STAFF REPORT

COMMUNITY DEVELOPMENT DEPARTMENT

HEARING DATE: 2/9/2021

SUBJECT: H-2020-0099
Mile High Pines

CONCEPT LANDSCAPE PLAN

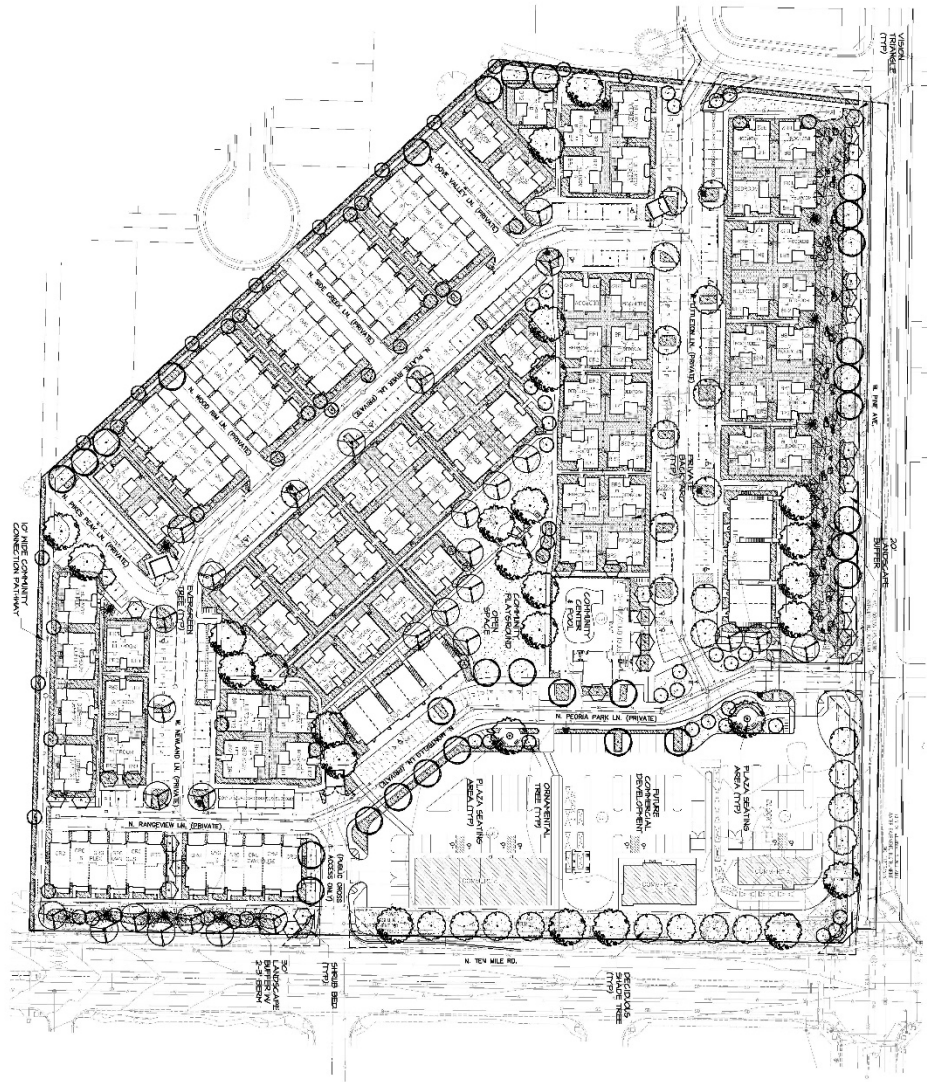
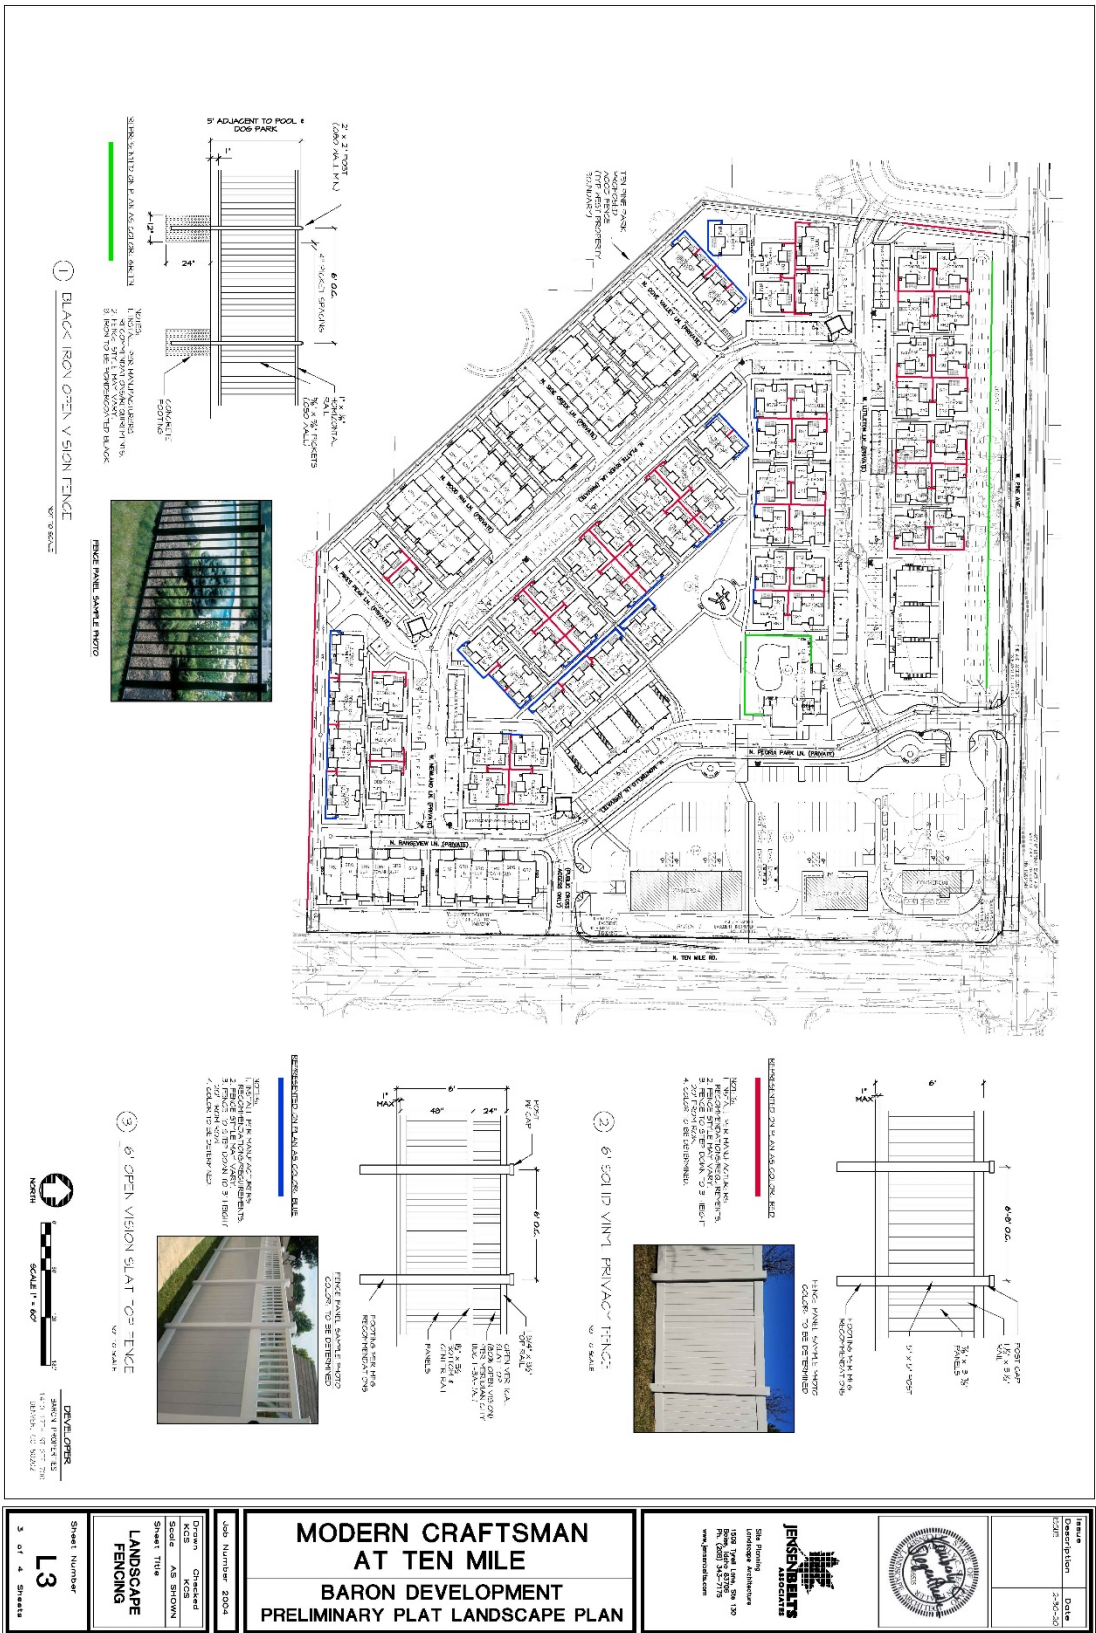
A 25-foot wide street buffer is required adjacent to N. Ten Mile Road, an arterial roadway, landscaped per the standards listed in *UDC 11-3B-7C*. A 25-foot wide common lot is depicted on the plat starting at the back of the existing attached sidewalk along Ten Mile, meeting the UDC requirements. There is also a required 20-foot wide landscape buffer adjacent to W. Pine Avenue, a residential collector roadway; the submitted plat also shows compliance with this requirement. The submitted landscape plans appear to show the correct amount of landscaping per the UDC standards for the landscape buffers.

Landscaping is required along all pathways (including micro-pathways) in accord with the standards listed in *UDC 11-3B-12C*. The total lineal feet of *all* pathways with the required and proposed number of trees are NOT included in the Landscape Calculations table on the submitted landscape plans, sheet L.4. The table contains this data for the multi-use pathway but not the micro-path along the west perimeter of the development **and there does not appear to be trees located on both sides of either pathway segments. The addition of this data in the calculations table and the required trees located on both sides of the pathways will be required as a condition of approval. In addition, there does not appear to be the minimum 5 feet wide planter width on the south side of the multi-use pathway. The submitted landscape plans appear to show an area wide enough for the pathway and 5 feet of landscaping on both sides; the Applicant should revise the landscape plans to show compliance with these standards.**

The proposed C-C zoning district requires a 25-foot landscape buffer to any residential district; the submitted plans do not show compliance with this requirement. Because this is a mixed-use development and there is the presence of some landscaping, a sidewalk, and the street between the residential uses and the commercial, Staff does not have particular concern over this discrepancy. However, in order to comply with the UDC, the Applicant will have to request a waiver from City Council to reduce this buffer to the buffer shown on the submitted landscape plans.

- ~~b. Revise the landscape plans to add a 5-foot wide landscape buffer along both sides of the pathways located along the perimeter of the site (including the multi-use pathway), landscaped in accord with UDC 11-3B-12.~~

- c. Show the required 25-foot landscape buffer between the C-C zoning district and the R-15 zoning district as required by UDC 11-3B-9C unless otherwise reduced by City Council waiver.

E. Pedestrian Circulation Plan

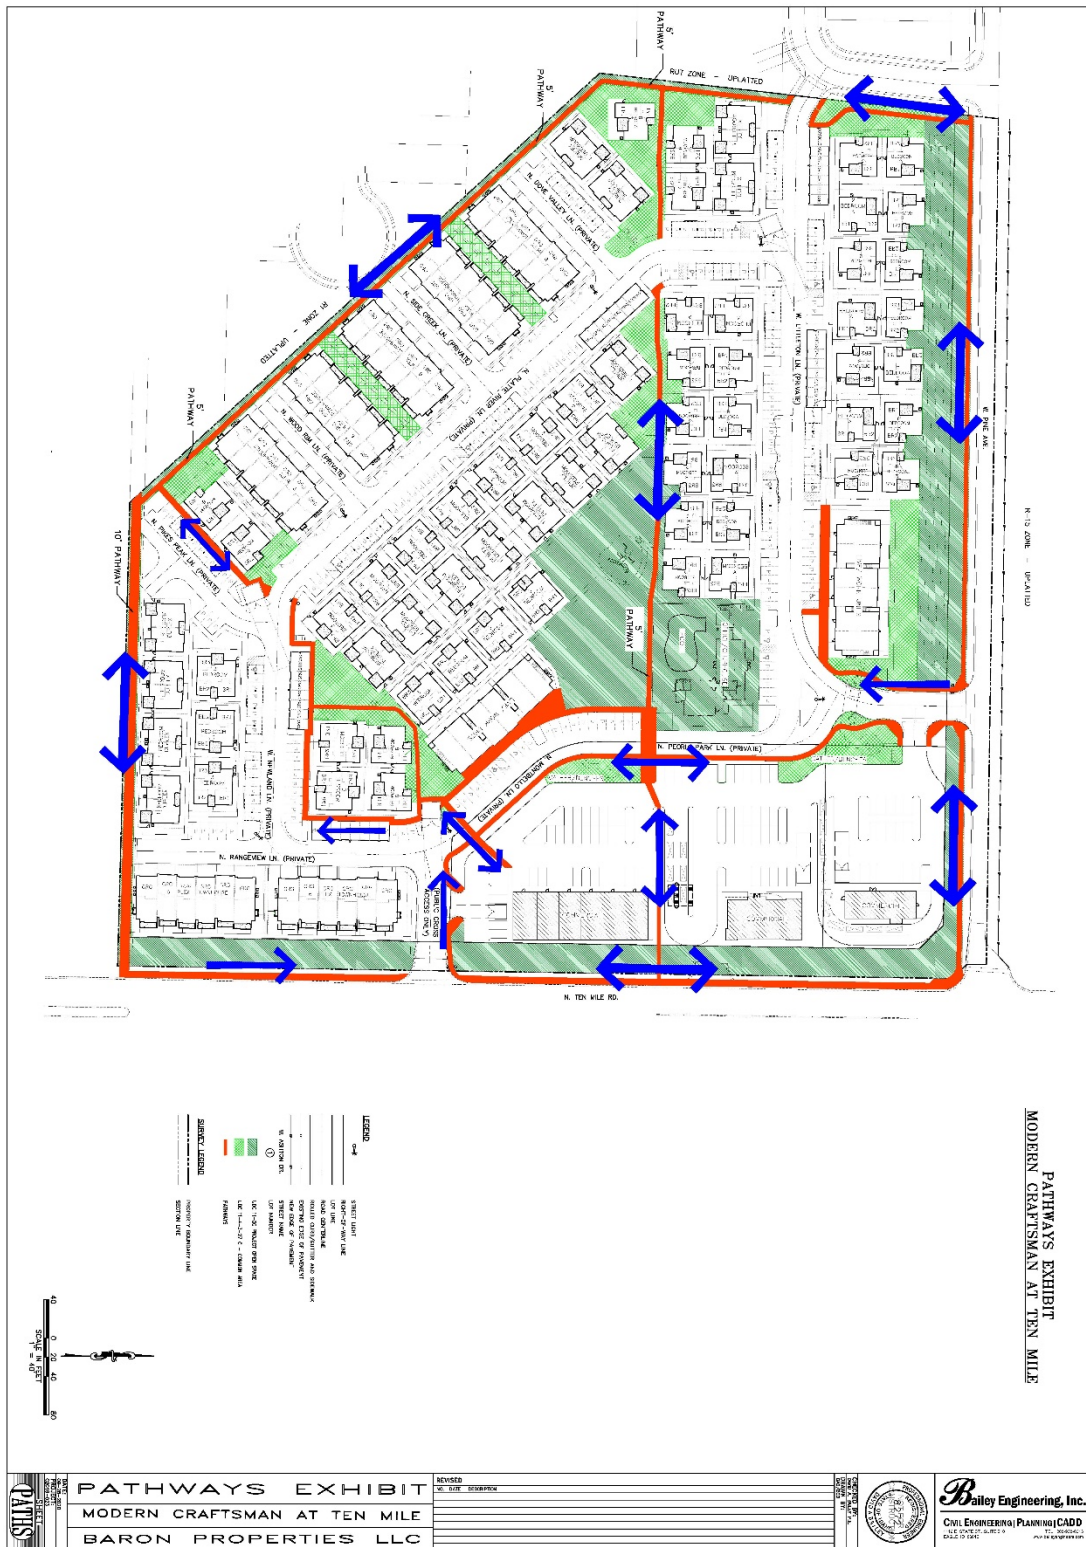
The sidewalks in this development create connections throughout the project including to and from the commercial portion of the site. The proposed large open space area in the center of the development is easily accessible because of these sidewalks. The sidewalk along Ten Mile is already existing with 7-foot attached sidewalk per ACHD standards for arterials. With the extension and construction of W. Pine Avenue, the Applicant is required to construct a 5-foot wide detached sidewalk within the required landscape buffer. The submitted landscape plans show a 5-foot detached at least 4 feet from the edge of future right-of-way, meeting UDC

standards. Staff supports the sidewalk and pedestrian circulation plan for this development. See Exhibit VII.F.

10. With the Final Plat submittal, the Applicant shall correct the applicable plans to show all pedestrian crossings as raised crossings and show the main pedestrian sidewalks that traverse through the development to be constructed with pavers or colored and stamped concrete (or equal) to further delineate the pedestrian pathways.
